**Defective Groundwater Protection Practices at the Sandia National Laboratories’
Mixed Waste Landfill – The Sandia MWL dump.
- Version January 22, 2011**

Robert H. Gilkeson, Registered Geologist
PO Box 670
Los Alamos, NM 87544
rhgilkeson@aol.com

David B. McCoy, Executive Director
Citizen Action New Mexico
POB 4276
Albuquerque, NM 87196-4276
505 262-1862
dave@radfreenm.org

Figure 3-8. Hydrograph of Water Levels in MWL-MW4

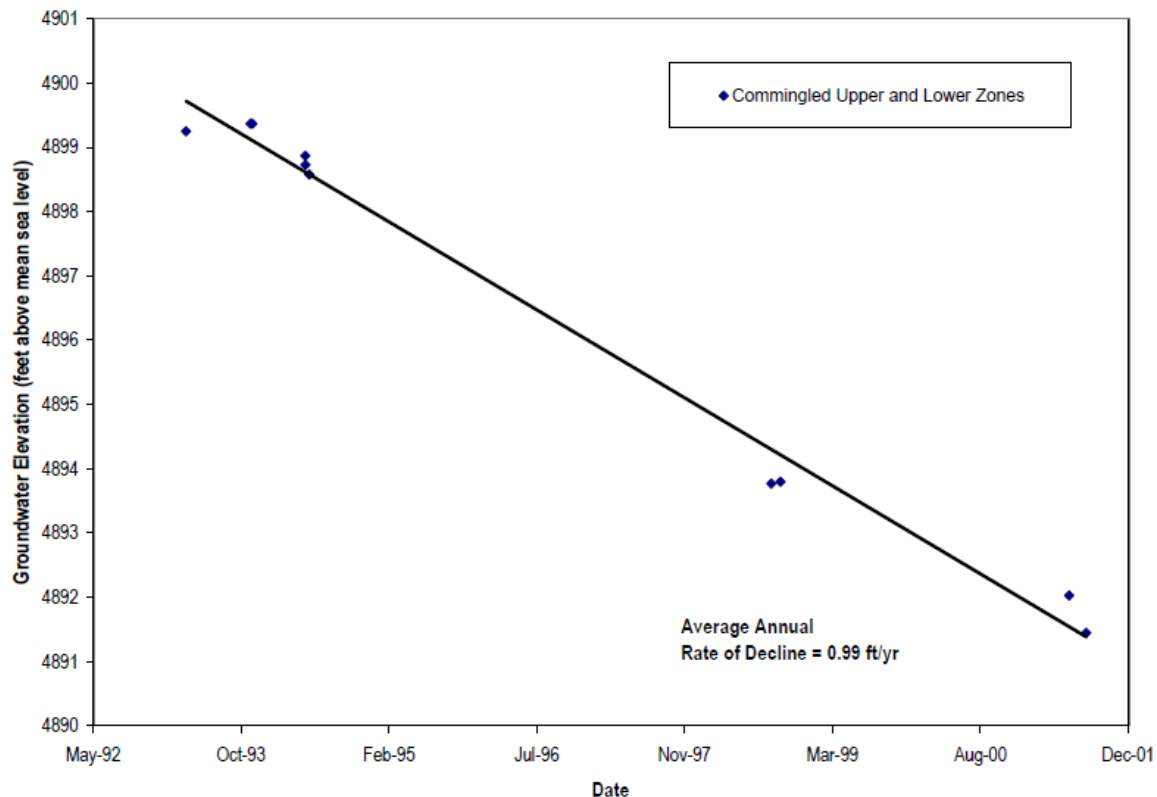
For MW4, the majority of post-05/23/1994 groundwater sample data are derived from samples from the upper screen, which also samples the AF Facies [i.e., the fine-grained alluvial fan sediments]. However, data from earlier groundwater samples were composites of groundwater from both screens, with groundwater hydrochemistry from the lower more-conductive ARG facies presumably dominant (Goering, 09/21/2006).

More than 16 months passed after the installation of monitoring well MWL-MW4 before a packer was installed on May 23, 1994 to prevent the open flow of possibly contaminated groundwater from the upper screen to the lower screen. In addition, the figure below from the DOE/Sandia report by Goering et al. (2002)⁹ shows that the packer was removed from well MWL-MW4 for unknown periods of time in 1998 and 2001 because the figure describes the water levels measured in many years as “Commingled Upper and Lower Zones.”

Cross-contamination between different zones of saturation is not permissible under RCRA or the NMED Sandia Consent Order ¹. The long periods of groundwater flow between the upper and lower screen in well MWL-MW4 is an example of the failure of the NMED HWB to enforce the regulations and protect public health.
